# PERMIT

SEWAGE DISPOSAL SYSTEM

MARYLAND STATE DEPARTMENT OF HEALTH

SUBDIVISION \_\_\_\_\_ ROAD 2225 Daisy Road LOT #3

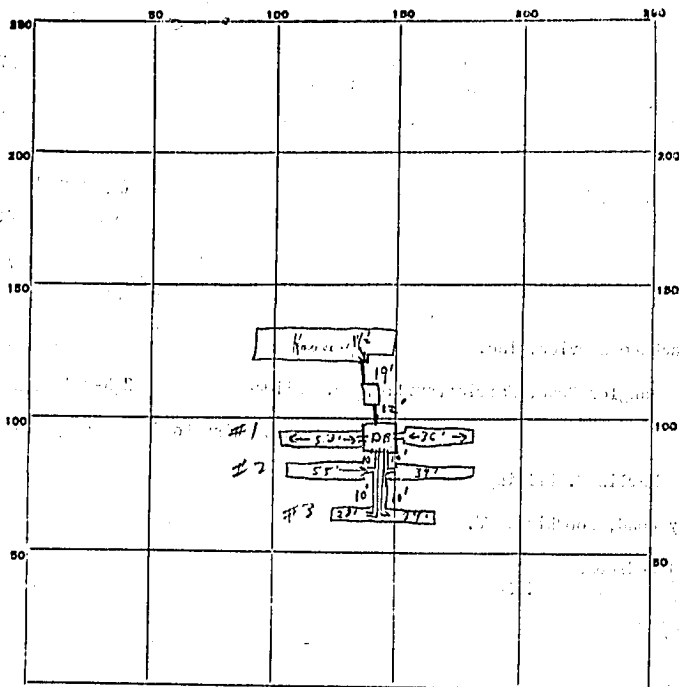
① & ② Daisy Road  
New near then old east to road S.T. / D.V.

4/13/98 OK - leaves top off as can check water

4/13/98 ① Need to leave all center pipes & pipes from leaves to tank & from tanks down open for check

Partial ok for gravel in trenches <sup>at</sup> top of trench

② 4/14/98 checked - all pipes in & cemented at tanks & D.B. <sup>C.B.S.</sup>  
Put top on D.B. & cover all work. - Carlson to D.B.
